**Submission to the Parramatta Light Rail Stage 2 SS1 10035 from the Owners of  
29 & 31 Hope St, Melrose Park**

This submission is provided on behalf of the Owner of 31 Hope St, Melrose Park. Our submission is based on the following :

Land Zoning Map - Sheet LZN\_018

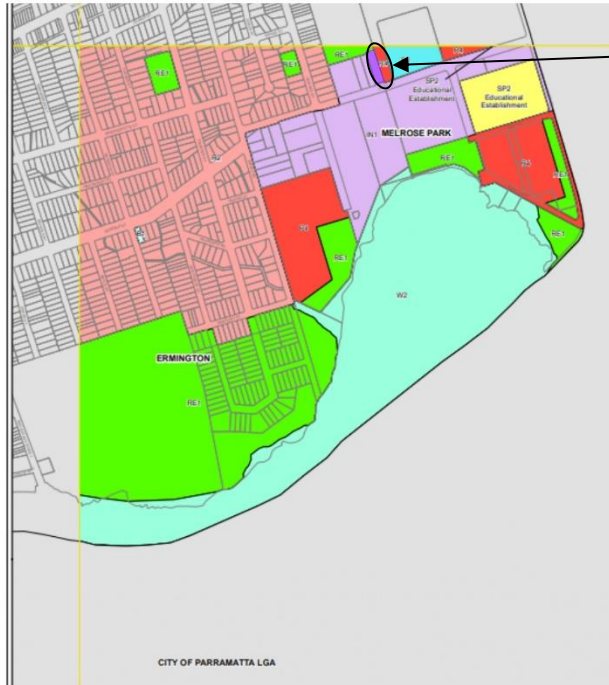
- The current Land Zoning Maps from the Parramatta LEP (maps 17 and 18) which follow show the intrusion of the IN1 industrial land:

31 Hope St

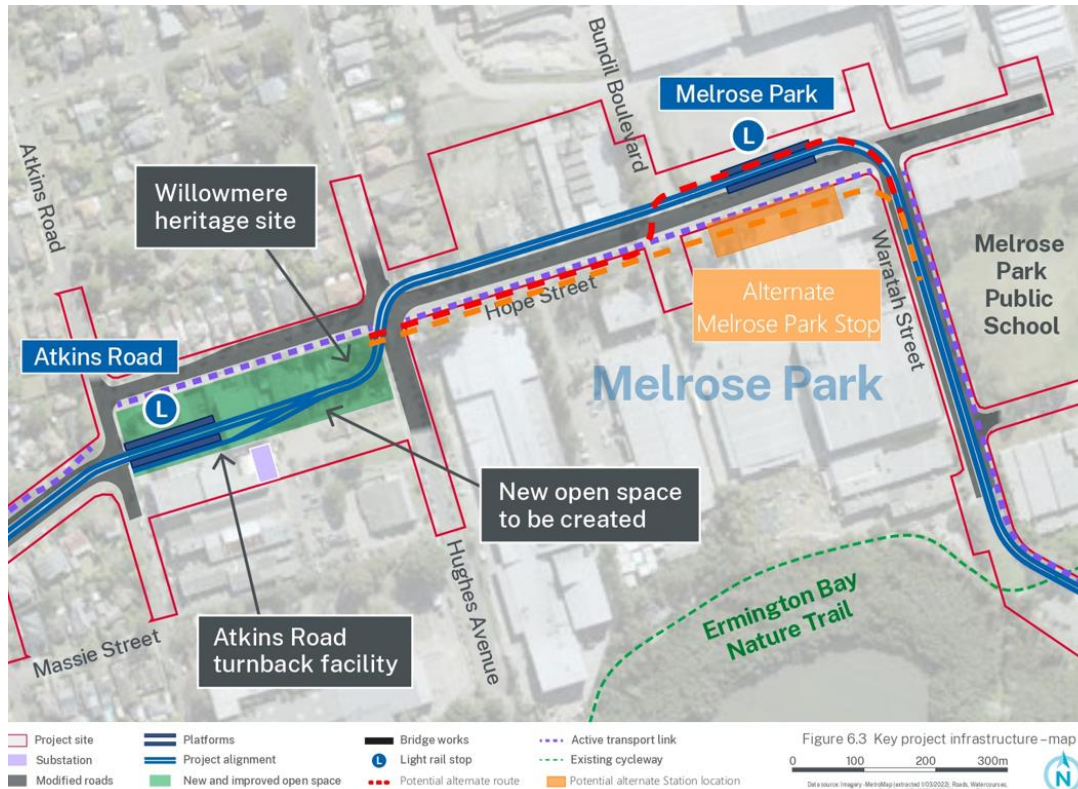
- It is submitted the proper and best functioning of the Melrose Park North and South precincts will be achieved by either of two other options for the route of the Light Rail along Hope St. These will result in better overall planning and redevelopment of the area.

- Currently as per *Technical Paper 1 Design, Place and Movement*, chapter 9.0 : Melrose Park, Fig 9.4.2 Hope St, it is proposed that the Light Rail to cross Hope Street twice. This being to the northern side of Hope Street at Hughes Avenue after the Atkins Road stop and then it crosses south back over Hope Street to go to Waratah Street. (refer to Fig 6.3 map 3 & Tech Paper 9.4.2 Hope Street)
- To do this the report states that it needs to encroach in the order of 12m into some 300m of frontage to 7 properties on the north side of Hope Street being properties 77 Hughes Avenue and 19, 27, 29, 31 Hope Street.

- From a Planning and Urban Design point of view it would be far more preferable for :
  - all of the IN1 land to be on the south side of Hope St
  - and all of the R4 land be consolidated on the north site of Hope St
  - so there is no interface and amenity issues of having IN1 land adjacent to R4 land ~ which is a key objective of the Central Sydney Planning Committee for all areas of Sydney

- This can be achieved if the light rail route continues in a straight line from the Atkins Road Stop from which it then crosses Hughes St from which it can either :
  - Continue on the southern side of Hope Street before crossing to the north side at the New Road Bundil Boulevard to service the proposed town centre at 33 Hope Street, before returning south again onto Waratah Street
    - *This is shown as the red dotted lines on the diagram on the following page*
    - With this there would only be 2 properties affected being 2 and 4 Hope Street, which would enable the light rail to service the town centre of 33 Hope Street and our Clients and the adjacent properties would not be effected.
    - with this there would be many advantages to the operation and functioning of the area.

- Or follow an alternate route fully on the southern side of Hope Street. This would include the Melrose Park Stop.
    - *This is shown as the orange dotted lines on the diagram on the following page*
    - This would take away the amenity conflict of having the light rail adjacent the R4 land. Residences would enjoy the moved amenity.
    - This also would have the advantage that the route would NOT have to cross the “Sydney Water Trunk Mains” which is identified in the report as a problem with this layout
